BUCKINGHAM TOWN COUNCIL

BUCKINGHAM TOWN COUNCIL INTERIM COUNCIL MONDAY 25th FEBRUARY 2019

NEW PLANNING APPLICATION

19/00511/APP

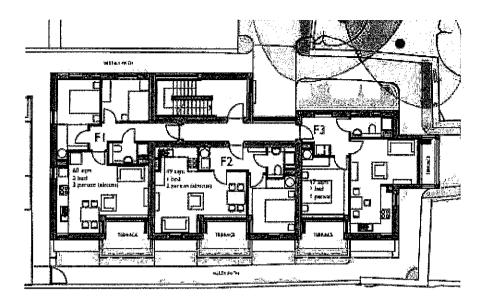
Ground floor & site layout; existing buildings are shaded in. The bottom edge of the drawing shows the site behind 10 Market Square, where there is approval for 2 flats (left) and 2 bungalows (right) shown by dashed lines; the gap arrowed between is the 'amenity area' for the two flats and one of the bungalows.

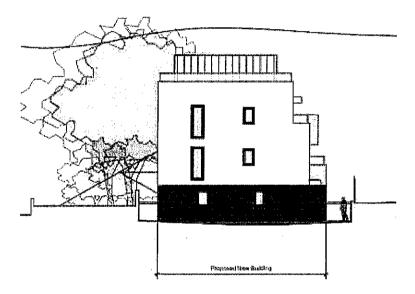
The flats at this end of the building are very close to the drycleaners' venting.

At ground, first and second floor this is the two-bedroom flat. The long left hand window is a bedroom, the right hand the kitchen/dining/living room. There is no indication that these are to be obscure glazed for (mutual) privacy.

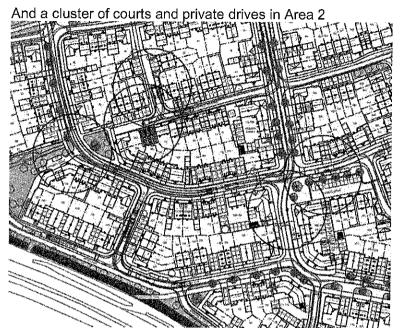
22e. The Waste & Recycling Officer has noted some hauling distances greater than 15m, and some skip ones (for the flats) greater than 10m and asked for this to be looked at again. (Truck run blue, collection point red, red circle is 25m radius)

There is one court in Area 1
